# UNITED STATES PATENT AND TRADEMARK OFFICE

10/812,618

<b>Office Action Summary</b>	<b>Application No.</b>	<b>Applicant(s)</b>	
	10/812,618	DHUPER ET AL.	
	<b>Examiner</b>	<b>Art Unit</b>	
	Teena Mitchell	3771

## DETAILED ACTION

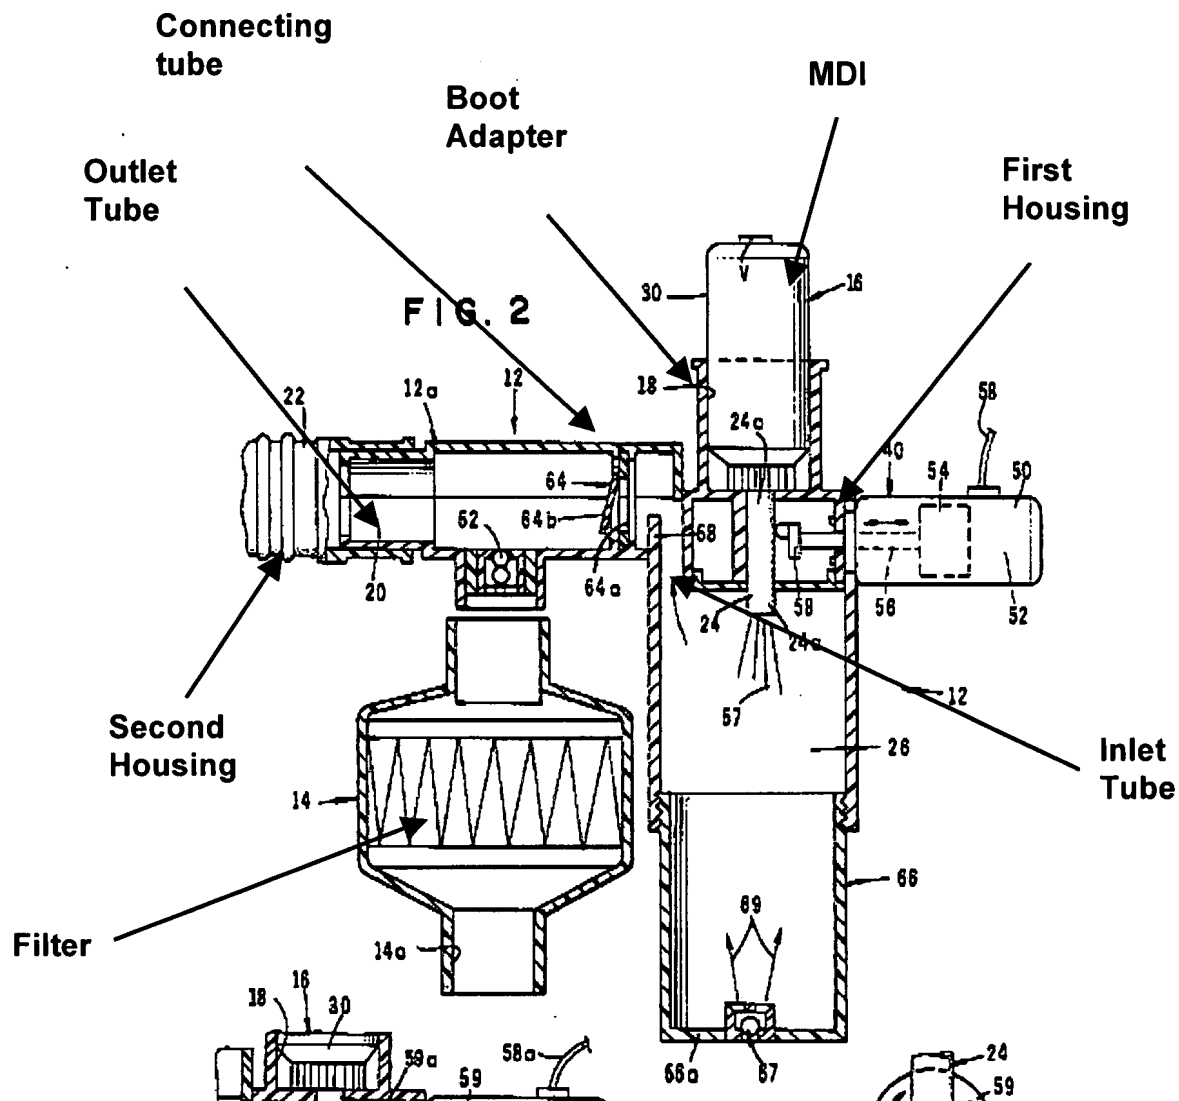
Regarding claim 1, King discloses a fixed first housing with a configuration of a cylinder (note illustration of Fig. 2 below), a fixed second housing; the first housing that is connected to the second housing through one of more peripheral and/or central hollow connecting tubes (note illustration of Fig. 2 below); the first housing with an inhalation/exhalation outlet tube at an inhalation/exhalation end of the first housing (Fig. 2 below); the inhalation/exhalation outlet tube with an inhalation/exhalation outlet port at the end of the inhalation/exhalation outlet tube (Fig. 2 below); the first housing with an inlet tube at a diametrically opposite end of the inhalation/exhalation outlet tube (Figs. 2 below); the inlet tube with an inlet port at an end of the inlet tube (Fig. 2 below); a boot adapter panel (Figs. 2 below) with an opening for receiving a boot of an MDI inhaler; a one-way inhalation flap valve assembly (at 64) that comprises an inhalation flap valve (at 64b), and a valve seat (64a) for the inhalation flap valve that is disposed in the outlet port of the outlet tubing of the first housing; the one way valve assembly (at 64) whereby inhalation by a patient through the inhalation/exhalation outlet port will cause the inhalation flap valve to move away from the inhalation flap valve

seat (64a) to allow one way flow of gas(es) from the first housing to a mouth piece or a face mask (Col. 3, lines 52-59) through the inhalation/exhalation outlet port of the first housing presses the inhalation flap against the inhalation flap valve seat (64a) to prevent the flow of exhaled gas into the first housing; a one way exhalation flap valve assembly (at 62), the difference between King and claim 1 is the exhalation flap valve seat. King discloses a ball check valve in the exhalation flap assembly, which does have a valve seat however not the same seat as the flap valve of the inhalation valve, inasmuch as the inhalation type flap valve as well known it would have been obvious to one of ordinary skill in the art to substitute the ball check valve in the exhalation pathway to the valve assembly of the inhalation pathway as one well known valve means for another. King discloses an exhalation filter (14).
